**SITE PLAN REVIEW SHEET
HILL COUNTRY ROADWAY
AND
ENVIRONMENTAL VARIANCE REQUEST**

CASE NUMBER: SPC-2011-0190C

PROJECT NAME: Loop 360 Climatized Self Storage

MEMORANDUM

VARIANCE EXHIBIT B FOR CUT IN
EXCESS OF 4 FT FOR AREA OUTSIDE
OF WQ/DET PONDS (LDC-25-8-341)

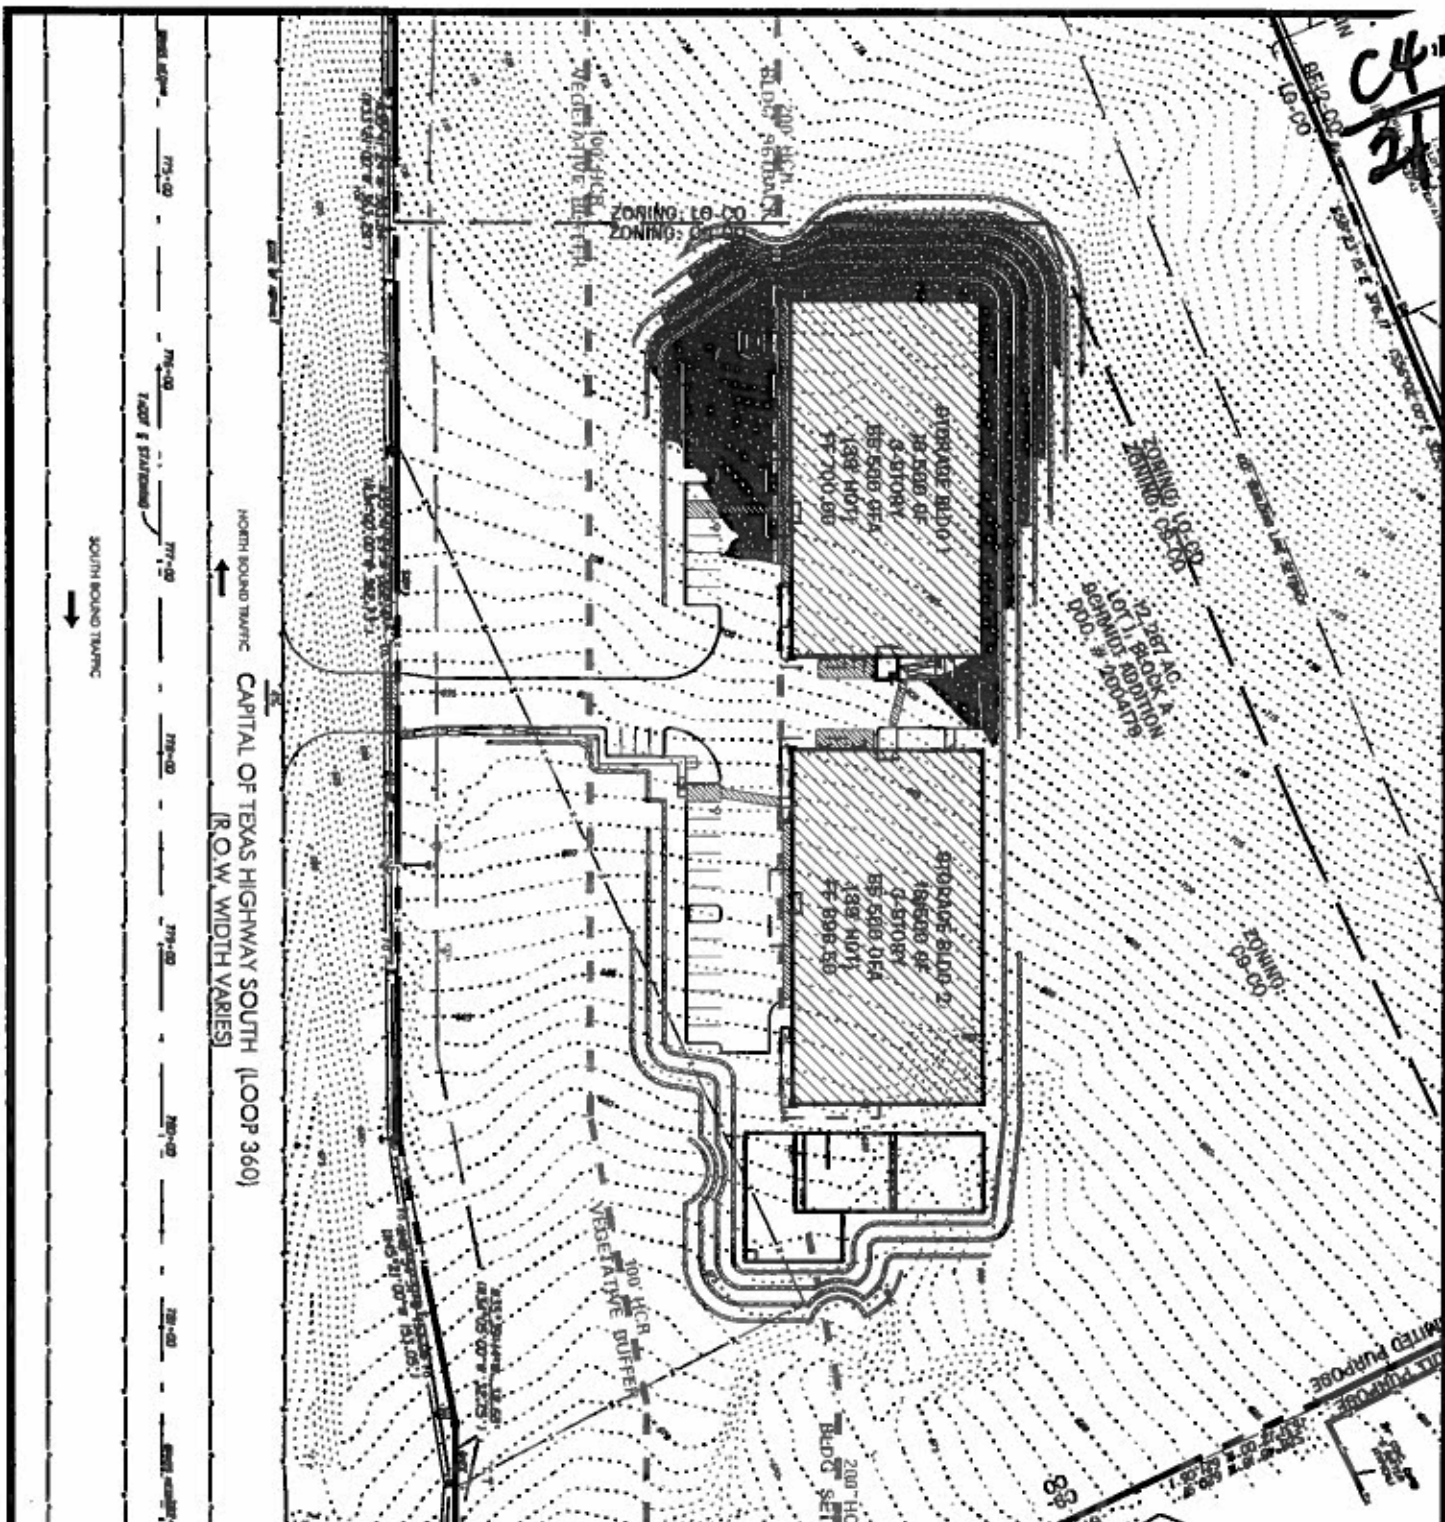
A schematic showing the extent of this variance has been attached as Exhibit B. This exhibit shows the extent of a variance from LDC §25-8-341 for cuts from 4' to 22' in depth as being 20,937 sq. ft. The scope of this variance has been minimized to the greatest extent feasible by: 1) adopting a two-building concept with three stories each, thus minimizing the depth and area of the cuts, and 2) by the use of terracing techniques.

20,937 SF CUT 4'-22"

1. Structural containment (terracing).
2. Restoration and revegetation

VARIANCE EXHIBIT A FOR STRUCTURAL EXCAVATION (CUT) IN EXCESS OF 8 FT (LDC-25-2-1123C)

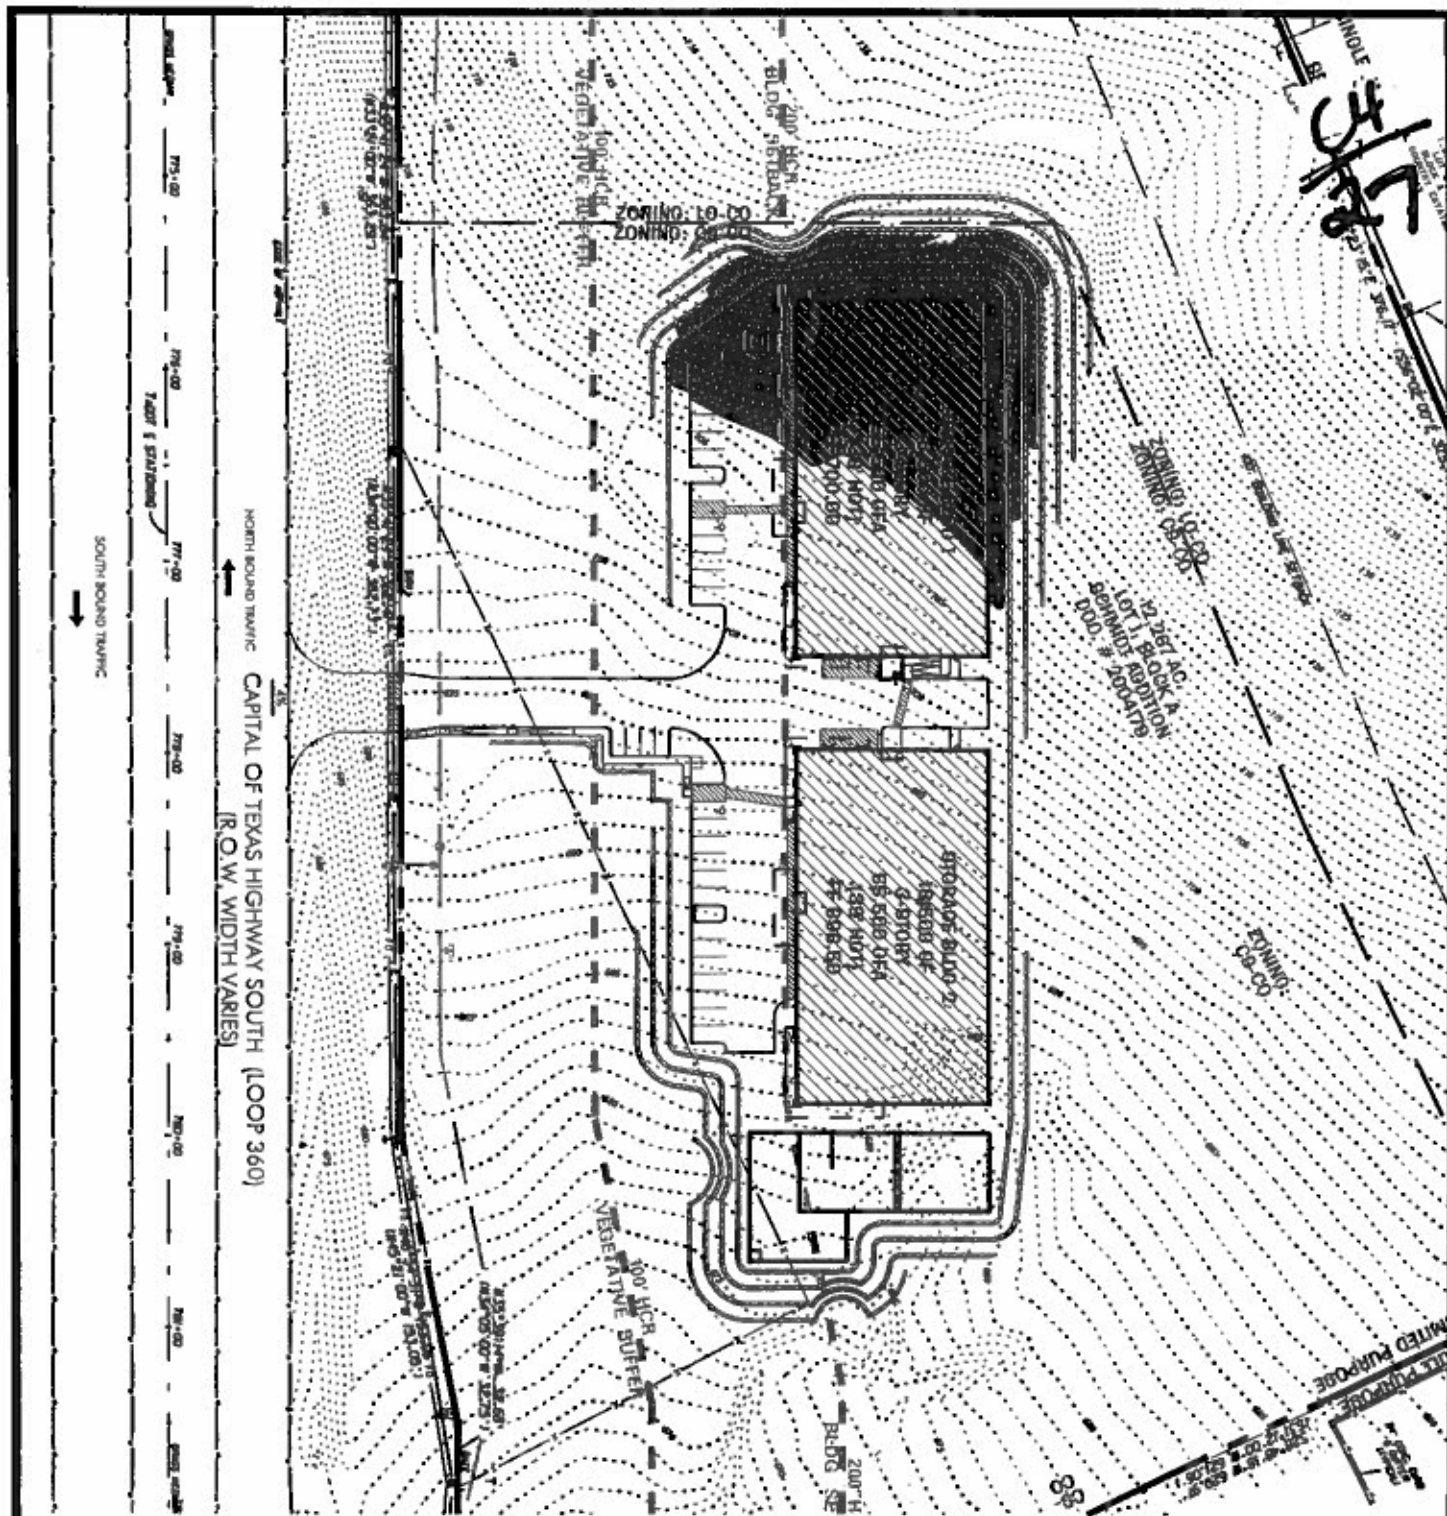
A schematic showing the extent of this variance has been attached as Exhibit A. This exhibit shows the extent of a variance from LDC §25-2-1123(C) for cut from 8' to 22' in depth as being 22,276 sq. ft.. The scope of this variance has been minimized to the greatest extent feasible by: 1) adopting a two-building concept with three stories each, thus minimizing the depth and area of the cuts and 2) by the use of terracing techniques.

22,276 SF CUT 8'-22'
